## GRUNT/CREAK/CHIRP/SQUEAK NOISE FROM THE FRONT LOWER CONTROL ARM OVER BUMPS

### TECHNICAL SERVICE BULLETIN

Reference Number(s): 13-9-3, Date of Issue: September 4, 2013

FORD: 2011-2014 Mustang

Figure 1 - Article 13-9-3

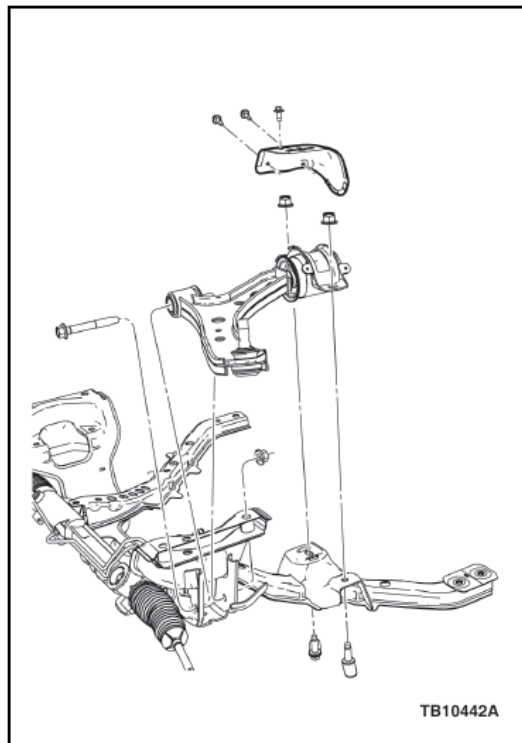
Some 2011-2014 Mustangs vehicles may exhibit a grunt/creak/chirp/squeak noise from the front lower control arm hydro bushing. These noises may occur over large vertical bumps like speed bumps, pot holes, rough roads and driveway approaches.

1. Attach Rotunda wireless chassis ears (JSP97202) or equivalent on both lower control arm hydro bushing bracket tabs to verify noise is coming from the hydro bushing.
  - a. The hydro bushing is the large diameter bushing at the rear of the control arm. Due to hydraulic fluid flow some noise from the bushing is normal. There would typically be some difference from side to side on a unit with a noisy control arm.
2. If the noise is not confirmed as coming from the hydro bushing, this article does not apply, refer to Workshop Manual (WSM), Section 204-00 for normal diagnostics.
3. If the noise is confirmed as coming from the hydro bushing, replace the affected lower control arm with the new lower control arm with shield and three (3) screws. Tighten the three (3) shield screws to 7 N.m (62 lb-in.) Refer to WSM, Section 204-01. (Figure 1)
